## BELMORE ROAD PRECINCT INITIAL NOTIFICATION – RESPONSE TO AGENCY SUBMISSIONS

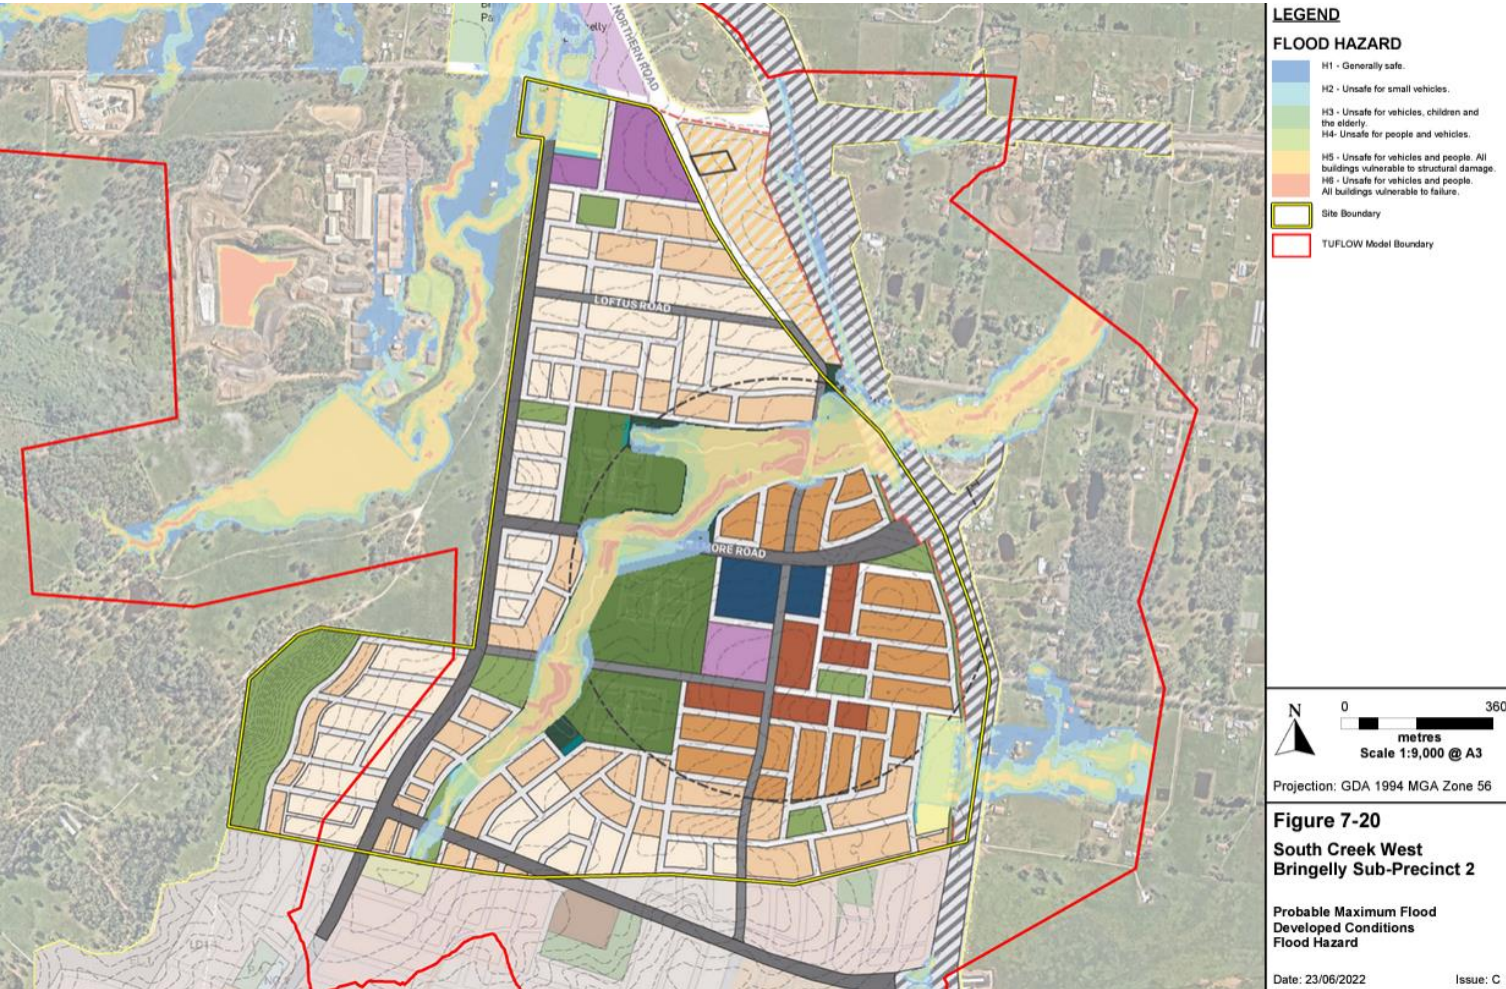
Agency Comment	Response	Changes to ILP to respond to comments
<b>EHG (now Department of Climate Change, Energy, the Environment and Water or DCCEEW)</b>		
<u>Requirements of the Growth Centres Biodiversity Certification Order</u> EHG requested that a Biodiversity Certification Consistency Report be submitted which is a legal requirement of the Biodiversity Certification Order for precinct plans and has not been provided.	This has been discussed with Council and will be undertaken once the ridgeline park option/ILP is agreed to.	No changes required.
<u>Inconsistencies within and between submitted documentation and matters requiring clarification relating to the protection of ENV and AHCVV</u> EHG requests that detention basins, raingardens and other stormwater infrastructure be located outside the C2 zone and included within the development footprint.	<p>Detention basins remain within the C2 zoning and will operate as dry detention basins which are fully vegetated. Basins remain outside of the core riparian corridor and will be re-planted with wetland species that will be able to withstand regular inundation.</p> <p>This aligns with other precincts including Lowes Creek Maryland.</p> <p><i>Drainage; Environmental facilities; Environmental protection works; Flood mitigation works; and Recreation areas</i> are all permissible in the E2/C2 Environmental Conservation zone. As such, the zoning does not prevent the location of drainage basins in their current location.</p> <p>No excavation or tree removal is required in the channels to allow these basins to be developed. In</p>	<p>Overall, the ILP has been amended to protect 8.73ha of Cumberland Plain Woodland and 0.6ha of river-flat Eucalypt Forest within the riparian corridor. This calculation does not include areas identified for drainage.</p> <p>It is also noted in the Biodiversity Report prepared by EcoLogical as part of the October 2023 package that the majority of the Belmore Road Precinct is biodiversity certified. A small portion within the southwest of the site is non-certified however it does contain any vegetation identified for protection in the <i>Draft Growth Centres Conservation Plan 2007</i>. Therefore, the Belmore Road Precinct is not obligated to retain any areas of ENV.</p> <p>The ILP has been updated since notification to introduce a third open space category – ‘Open Space – Tree Retention’. This allows for additional</p>

<p>accordance with Table 2 of the Guidelines for Controlled Activities on Waterfront Land (DPE, 2022), an online basin on a second order watercourse is permissible if the NRAR guidelines are met. These are identified within the Riparian Assessment prepared by EcoLogical as part of the October 2023 package.</p>	<p>tree retention (approximately 8 hectares of the canopy layer of Cumberland Plain Woodland) across the site which is in addition to ENV and AHCVV calculations. This allows for useable open space accessible to the community and allows for tree retention throughout the precinct.</p>
<b>Environment Protection Authority (EPA)</b>		
<p><u>Development adjacent to Bringelly Brickworks</u></p>	<p>Ongoing discussions have occurred with the Bringelly Brickworks. Employment land and low density residential is considered to have an appropriate buffer to the brickworks.</p> <p>The low density residential area along the western edge of Belmore Road Precinct is separated from Bringelly Brickworks by a distance of 30.6m at the minimum and 47.3m at the maximum. This distance represents the total road reserve of the sub-arterial road and the typical residential local road that runs parallel to it. Both road reserves act as transitional buffers. The intermittent planting areas across road reserves create a visual screen that diminishes the potential negative impacts of Bringelly Brickworks on the low density area along the western edge of the Precinct. The width of the intermitting planting areas range between 10m and 18m. These planting areas will have sufficient width and depth to support street trees planting with larger canopies.</p>	<p>Additional local roads are introduced adjacent to the sub-arterial road running along the western site boundary increasing separation between residential dwellings and the Bringelly Brickworks.</p> <p>Lots located along the sub-arterial road will have an orientation towards local roads. The lots will be oriented to the local road with secondary frontage to the sub-arterial road. Lots with secondary frontage to the sub-arterial road will require acoustic fencing or hedges to minimise potential noise and visual impact. Design guidelines for these acoustic fencing can be incorporated in the detailed design stage.</p>  <p>Lot layout and orientation along Sub-Arterial Road (Built Example Precedent: Oran Park)</p>
